**CHARTER TOWNSHIP OF VAN BUREN
PLANNING COMMISSION - VIRTUAL MEETING ON ZOOM
November 11, 2020
MINUTES**

Jiffy Lube Multicare Services Preliminary Site Plan Review

**Subject: VBT-20-012 Jiffy Lube / 9701 Belleville; Special Land Use Review #1; Revised Site Plans
Dated September 28, 2020.**

Subject: VBT-20-012 Jiffy Lube / 9701 Belleville; Site Plan Review #2; Revised Site Plan Dated September 28, 2020.

UTILITY EXHIBIT
NO SCALE

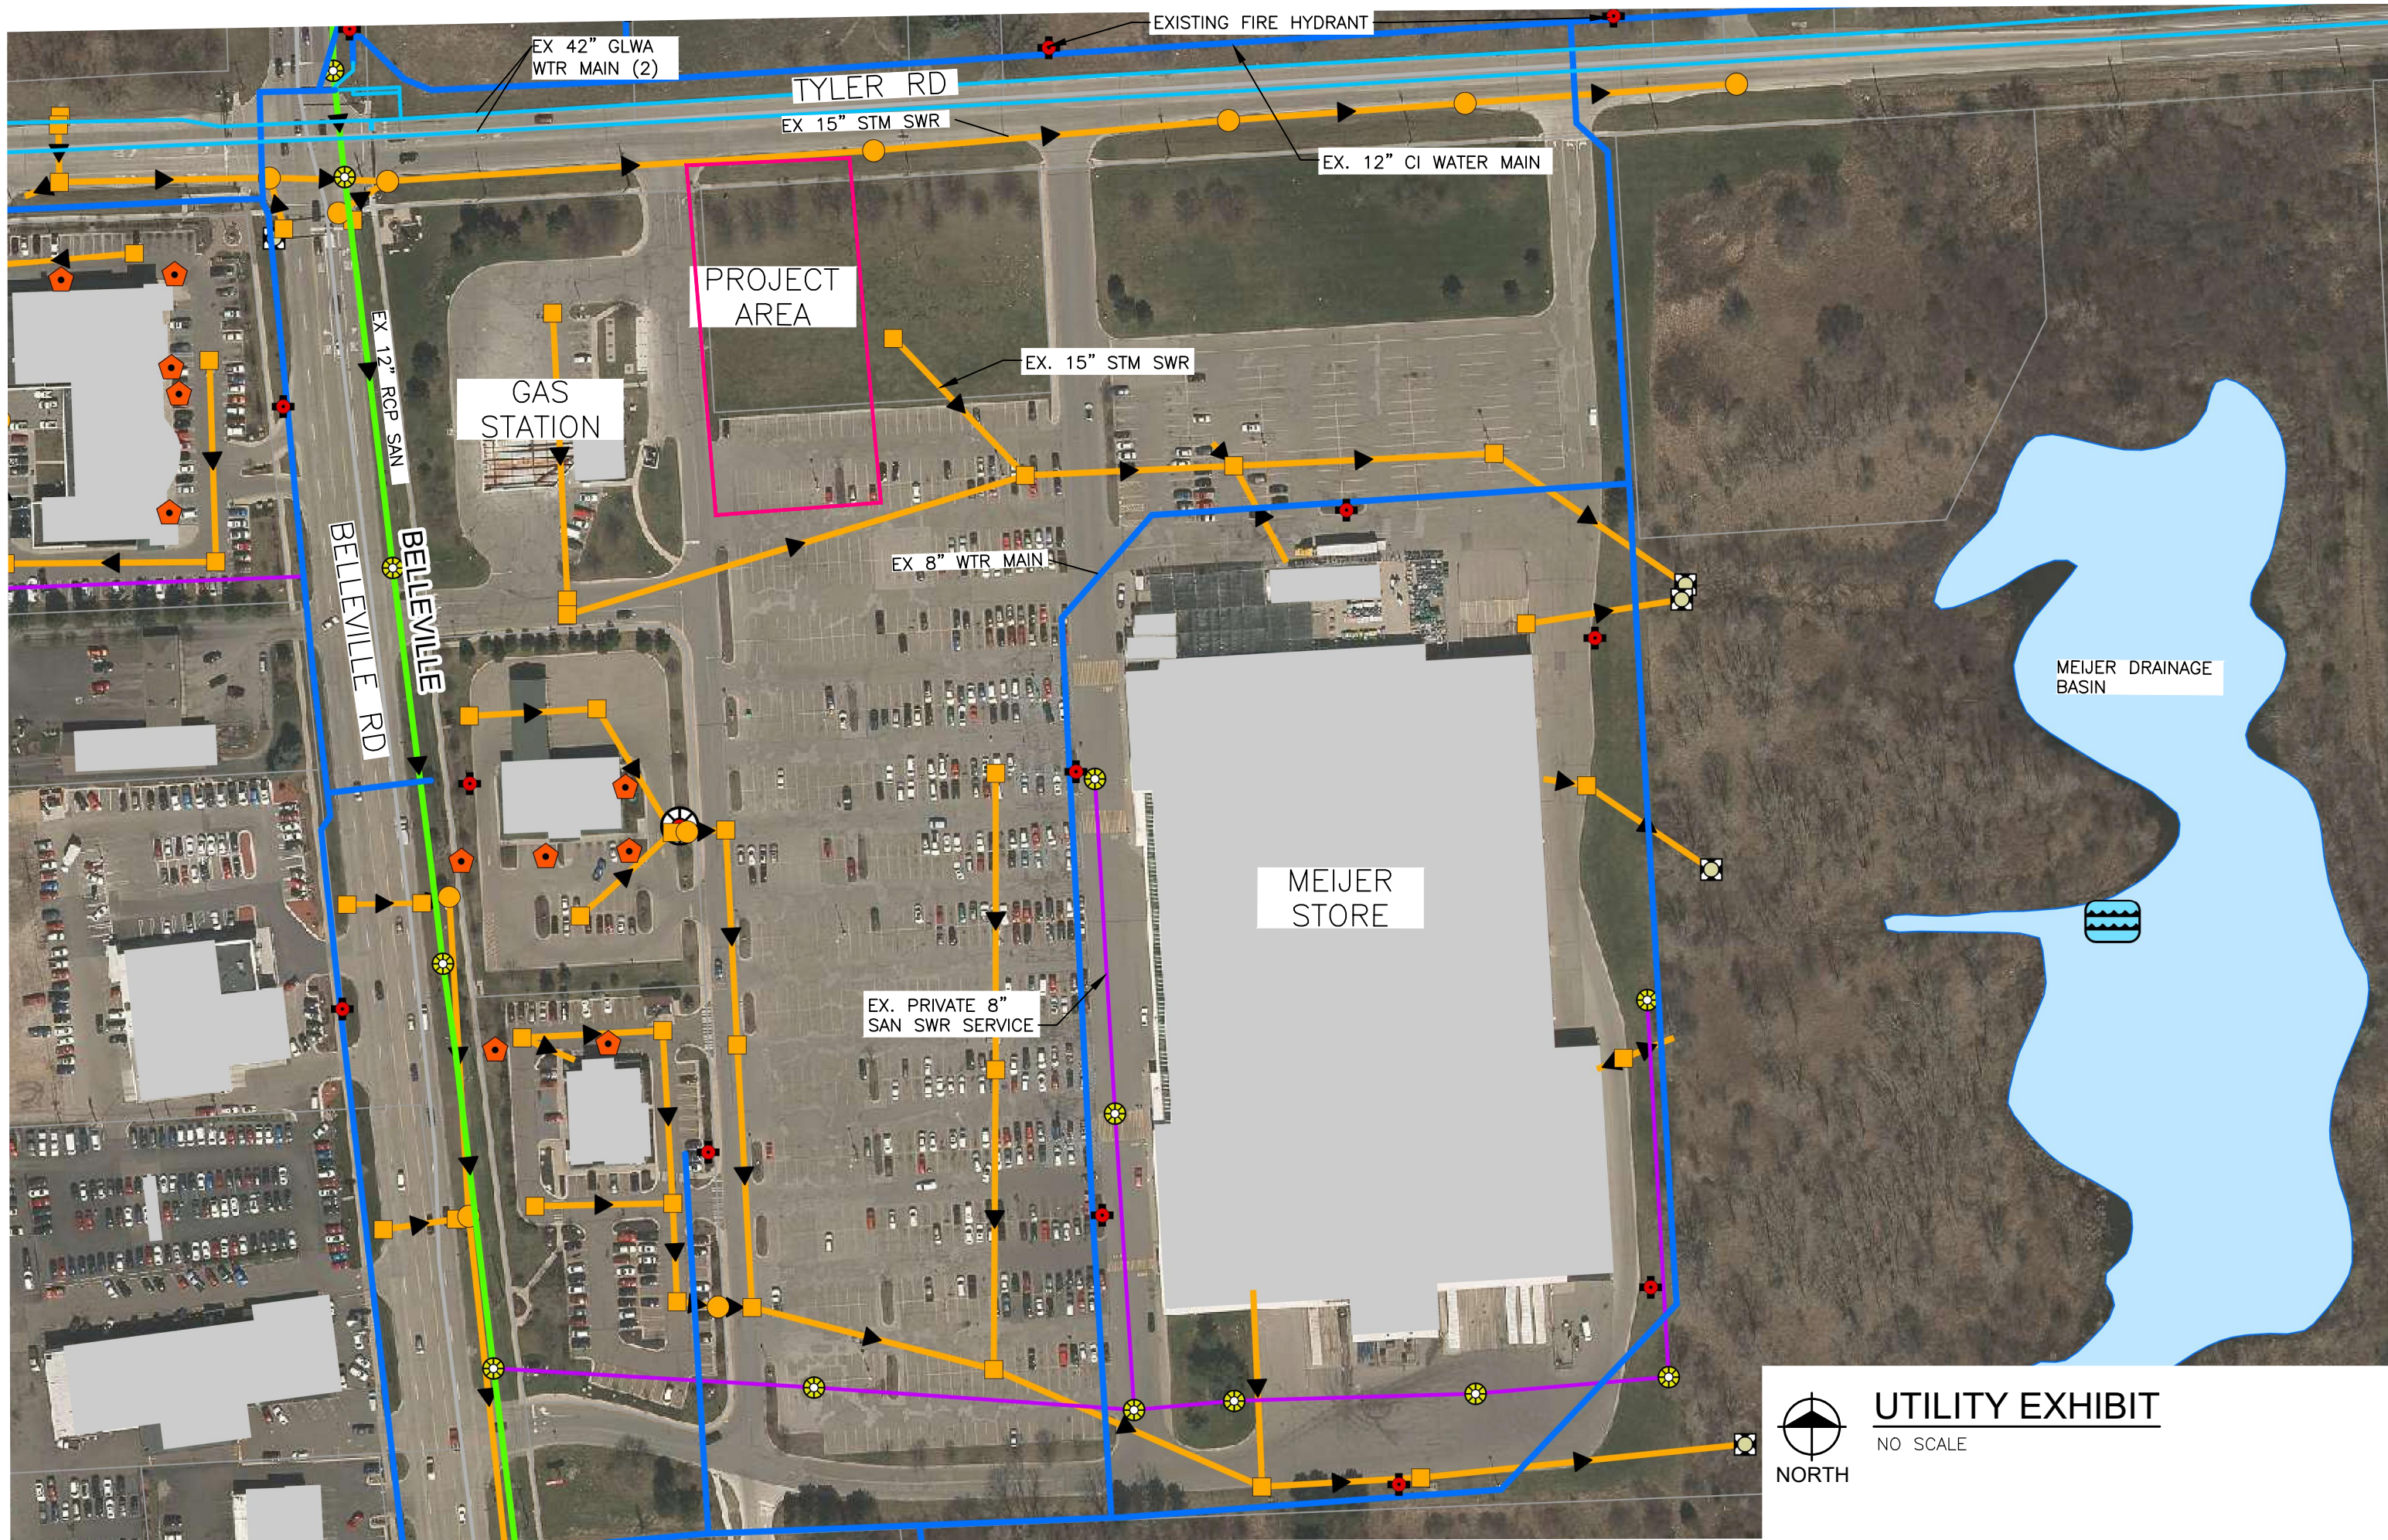
Existing: The Township's Geographic Information System (GIS) records indicate a publicly owned 12-inch cast iron water main running east-west along the north side of Tyler Road and two (2) 42-inch water mains running east-west along Tyler Road, which are owned and maintained by the Great Lakes Water Authority (GLWA). Records also indicate an 8-inch water main loop around the Meijer store building.

Proposed: The applicant's plan proposes installing an 8-inch water main connecting into the existing 8-inch water main inside the Meijer parking lot and connecting to the proposed building via a 2-inch copper type K water service line.

1. Applicant has indicated that, based on building construction type and square footage, building sprinklers are not required.
2. An easement agreement between Applicant and property owner (Meijer), for the extension of the proposed water main across private property, must be provided. Meijer will be required to grant said easement to the Township for the public water main. The easement must be centered on the water main, including bends.
3. An Michigan Department of Environment, Great Lakes, and Energy (EGLE) Act 399 Public Water Supply Permit will be required. The Applicant is responsible for completing the permit application, supplying the proper plan sets, and working with the Township to finalize the submittal. The Township will submit for the permit once all obligations of the application are met and the plans are finalized.

Existing: The Township's GIS records indicate that the closest sanitary sewer is a public 10-inch clay sanitary sewer running north-south along the east side of Belleville Road.

Proposed: The applicant's plan proposes a privately owned 6-inch sanitary sewer service, connecting into a newly proposed 8-inch public sanitary sewer running west through the adjacent Meijer gas station parking lot and connecting to the existing 10-inch sanitary sewer along Belleville Road via a wye connection.

1. Applicant must provide Basis of Design (BOD) calculations as part of the Engineering submittal. Once a basis of design is determined, and the proposed size is verified, further discussion regarding capacity and connection to the existing public 10-inch clay sanitary sewer along Belleville Road will be conducted.

2. Minimum size for public sanitary sewer shall be ten inches in diameter. If connecting to the existing sanitary system, this must be done at a manhole; existing or proposed.

3. All utilities along Belleville Road must be identified. Previous projects indicate a variety of utilities that will need to be identified and accounted for during connection to the existing sanitary main.

4. A soil boring near the location of the existing sanitary main connection is recommended, due to the need for deep excavations at the connection location.

5. An easement agreement between Applicant and property owner (Meijer), for the extension of the proposed sanitary sewer across private property, must be provided. Meijer will be required to grant said easement to the Township for the public sanitary sewer.

6. The minimum sanitary sewer easement shall be 20 feet.
7. A minimum horizontal separation of ten feet (measured outside of pipe to outside of pipe) must be maintained between the sewer and all other utilities.
